Wayne Riddell Loop Extension as adopted in the ASMP

PROJECT NAME: Wayne Riddell Loop

CASE #: C14-2019-0129

March 3, 2020 ZAP Q & A Report

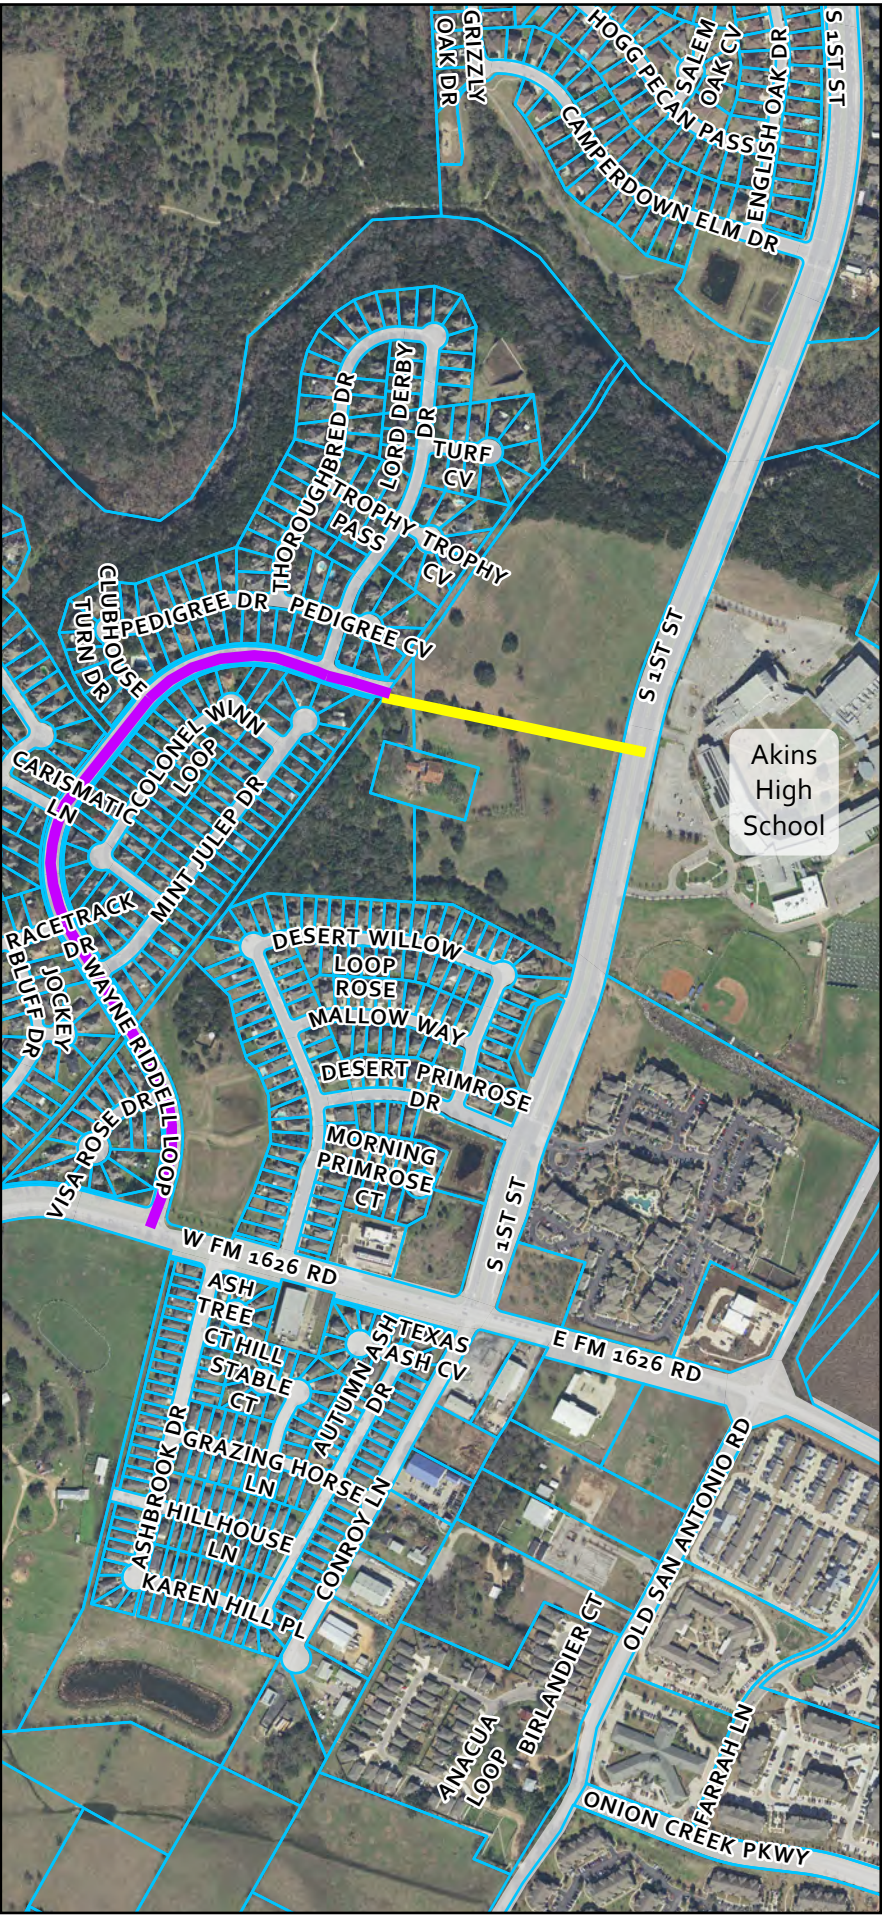
1. What are the requirements of the applicant with respect to the Wayne Riddell Loop extension with any site plan application?
 - a. Are they required to dedicate the right-of-way to the City for the purposes of the roadway construction? **Response:** Yes, ROW will be dedicated at time of subdivision or site plan.

- b. Are they required to build the connection? **Response:** Yes, the extension will be constructed at time of subdivision or site plan.
 - c. Can anything be constructed in the planned area of the roadway connection? **Response:** Only the Wayne Riddell Loop extension will be constructed in the planned area of the roadway connection. The applicant has split their development in two phases: one to the north and one to the south of this proposed extension.

- d. Is the signal at South 1st Street at the new connection included in the ASMP? **Response:** The Austin Strategic Mobility Plan (ASMP) identifies the signalization of the South 1st Street / Akins High School Driveway intersection as part of the long range transportation strategy in the area. The traffic signal was separately identified in the traffic impact analysis (TIA) as a required improvement to ensure the intersection operated safely and at an acceptable level once the Wayne Riddell Loop extension construction was complete and the site was fully developed. The traffic signal request from the ASMP did not play a role in ATD's decision to require a traffic signal at the future Wayne Riddell Loop / South 1st Street intersection.

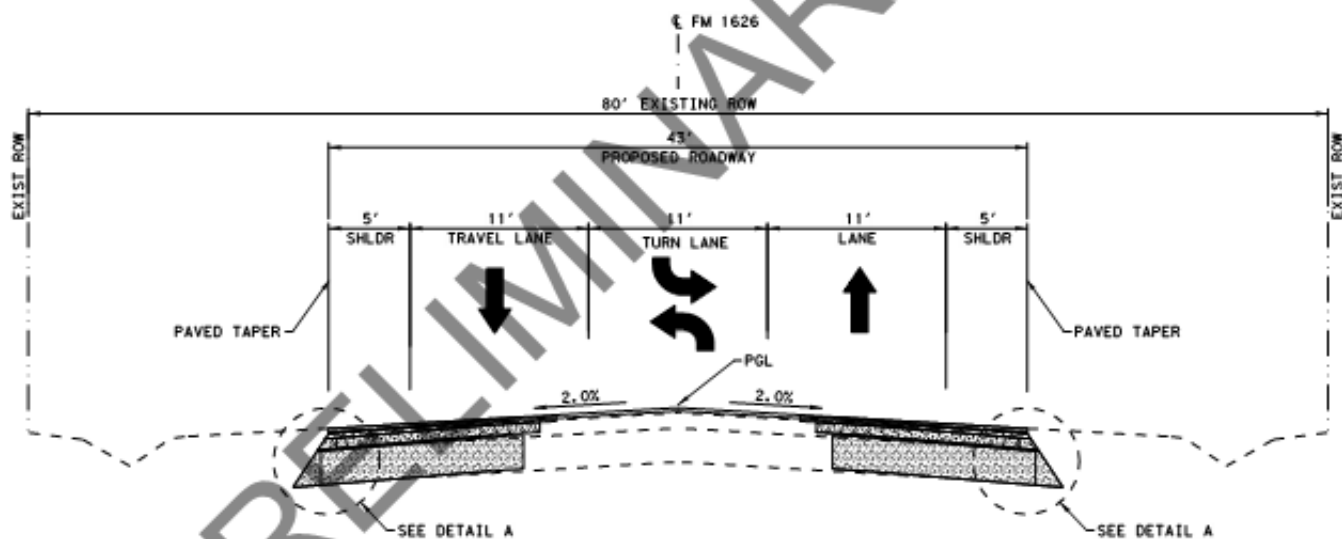
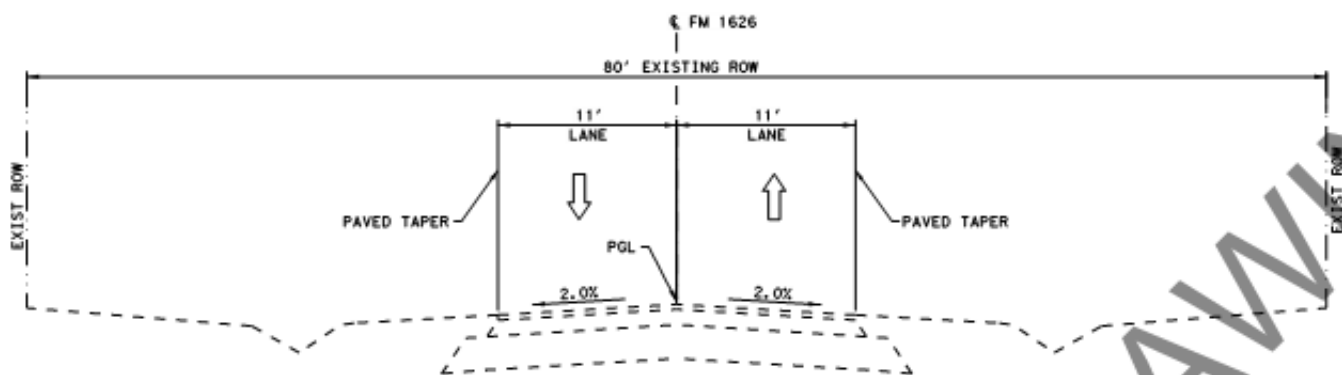
I realize drainage and environmental issues are done at time of site plan. However, can the drainage and/or environmental staff tell me if they're likely to be required to build ponds on site or they can contribute to a regional pond?

RESPONSE: Pending.
